**LOCAL HISTORIC DISTRICT:** Dilworth

**PROPERTY ADDRESS:** 2000 Park Road

**SUMMARY OF REQUEST:** Addition, fenestration changes, siding repairs, tree removal and site features

*Charlotte Historic District Commission - Case 2016-063*  
**HISTORIC DISTRICT: DILWORTH**

SITE, LANDSCAPE  
 & MATERIAL  
 DIAGRAM

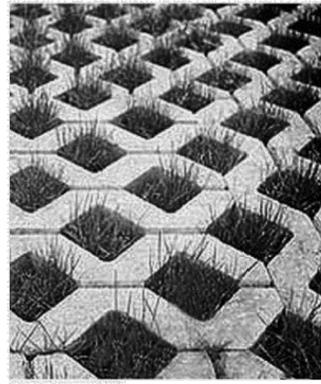
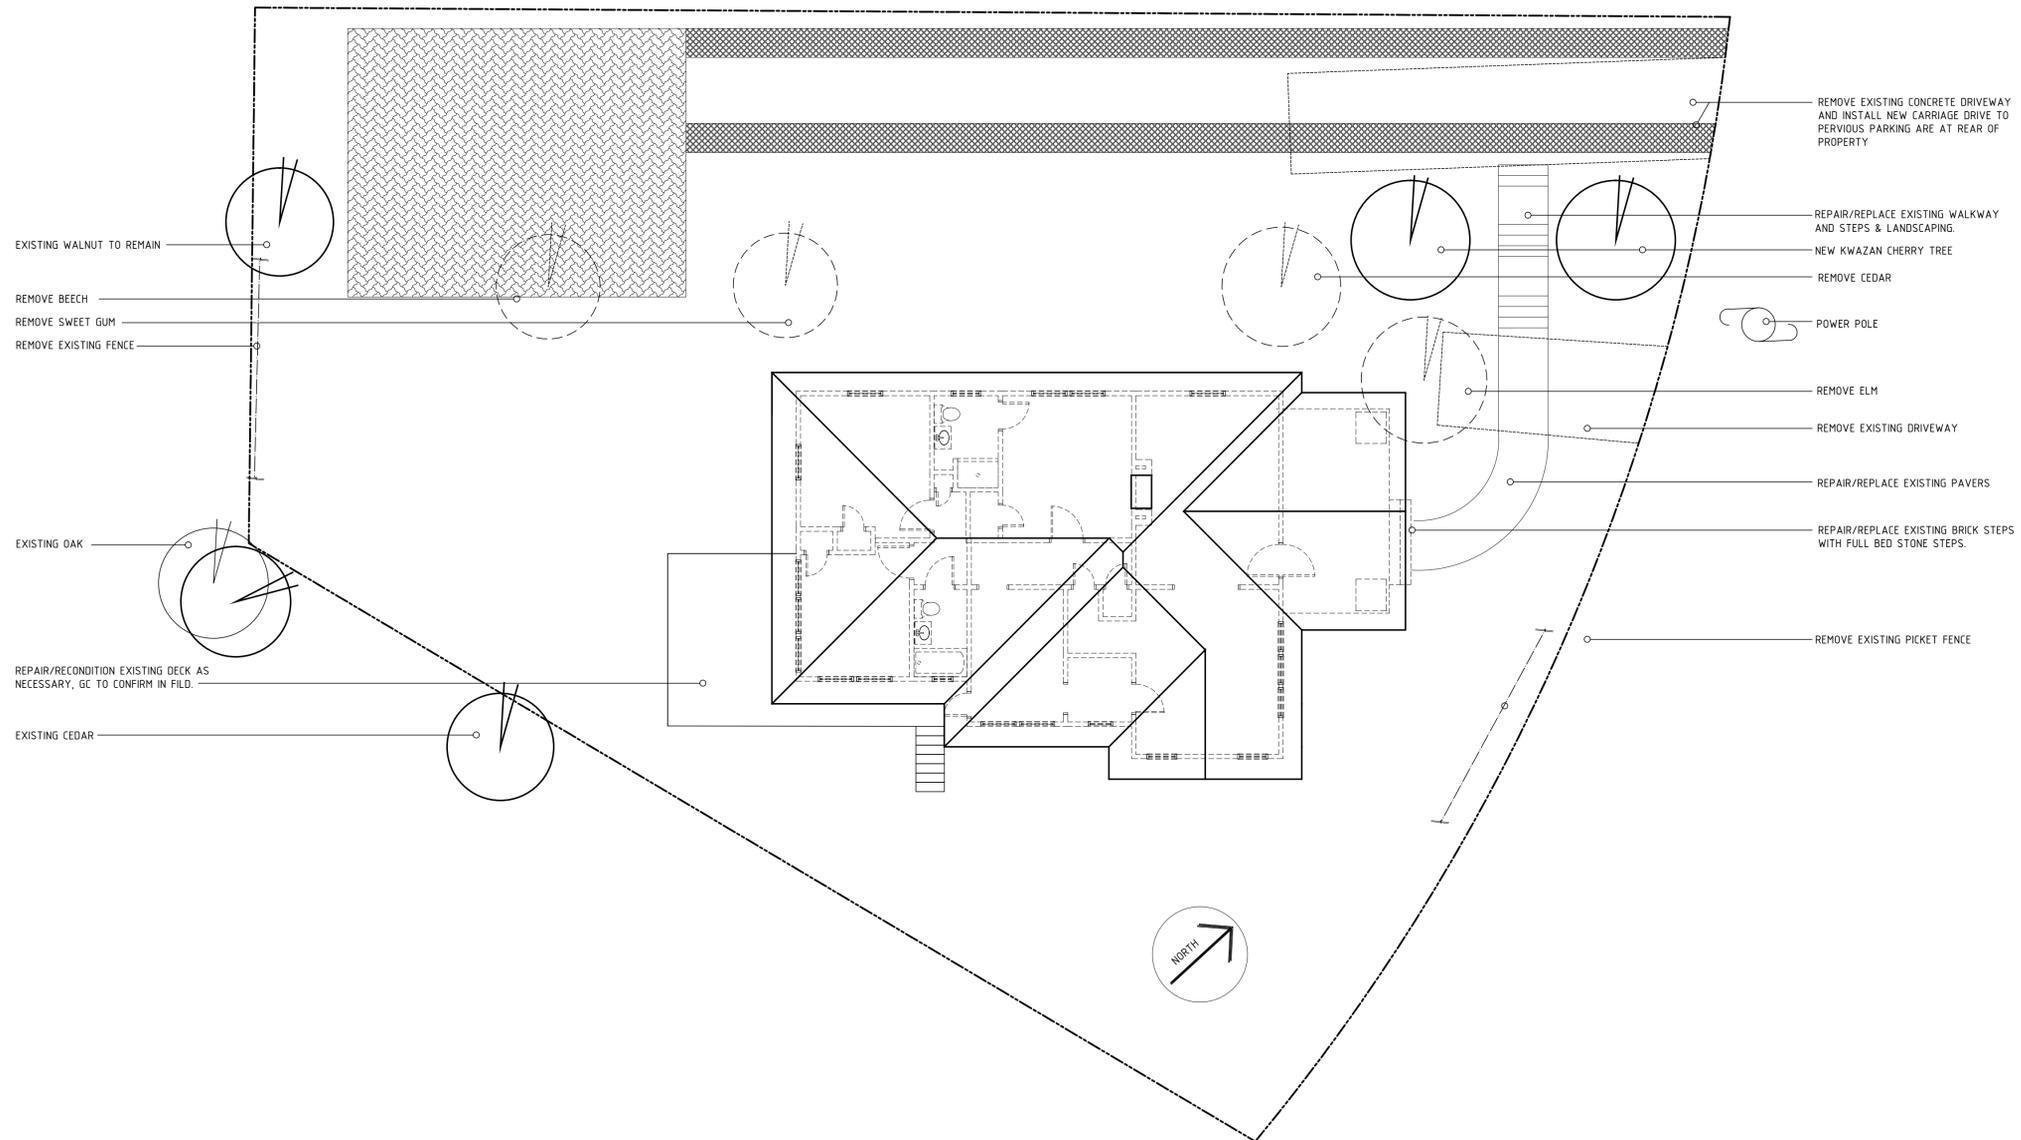
1. The applicant is requesting a new porch design and materials. The column base material has been changed to wood.
2. Two cherry trees are shown on the site plan in place of a cedar and elm that were removed without approval.
